SUNDRY NOTICES AND REPORTS ON WELLS

Empire Abo Unit N #14

WELL & JOB: EMPIRE ABO UNIT N-14 PLUG AND ABANDON

EMPIRE ABO UNIT N-14

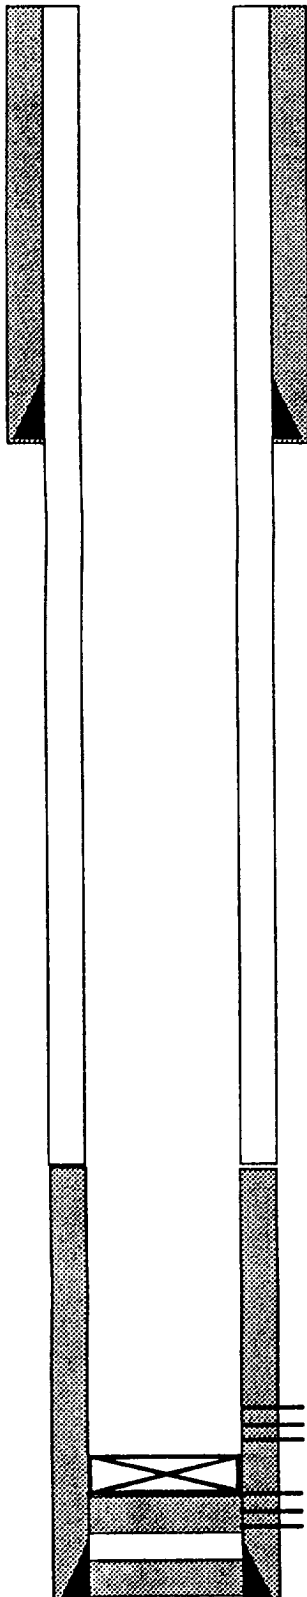
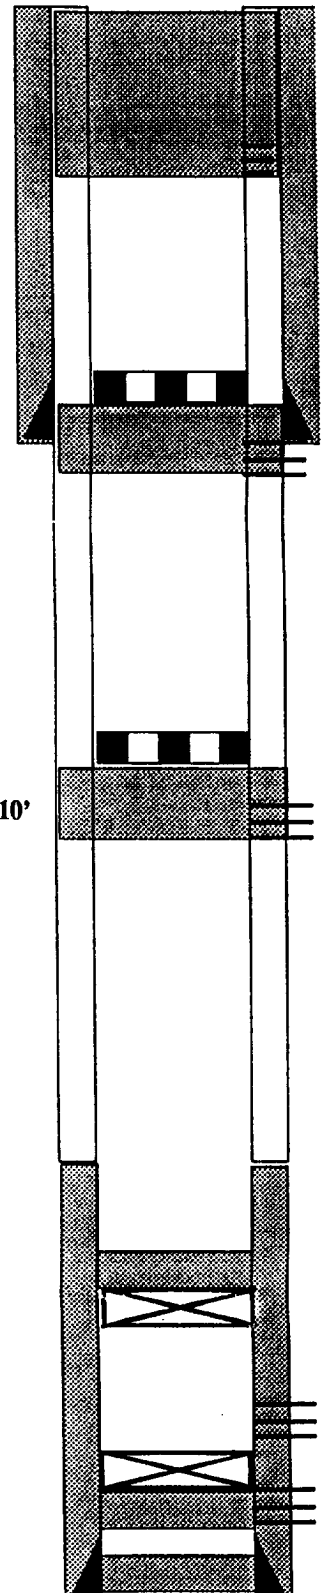
Propose to P&A as follows:

Plug	Interval	Cmt	Remarks
1	5225-5260	5 sx	CIBP w/35' cmt. WITH BAILER, OR 50' THROUGH TUBING.
2	1810-1960	60 sx	Perf at 1960. CR at 1860. (TO SA 1910)
3	954-1054	60 sx	Perf at 1054. CR at 954.
4	0-400	125 sx	Perf at 400. Circ cmt inside & out.

NOTIFY BLM PRIOR TO COMMENCING PLUGGING OPERATIONS.

PLACE LADEN MUD OF A MINIMUM WEIGHT OF 9.0 PPg BETWEEN PLUGS.

USE CLASS "C" CEMENT w/2% CaCl₂ MIXED WITH 6.3 Gals OF FRESH WATER PER SACK, AND SLURRY WEIGHT OF 14.8 PPg.

Approved as to plugging of the well bore.
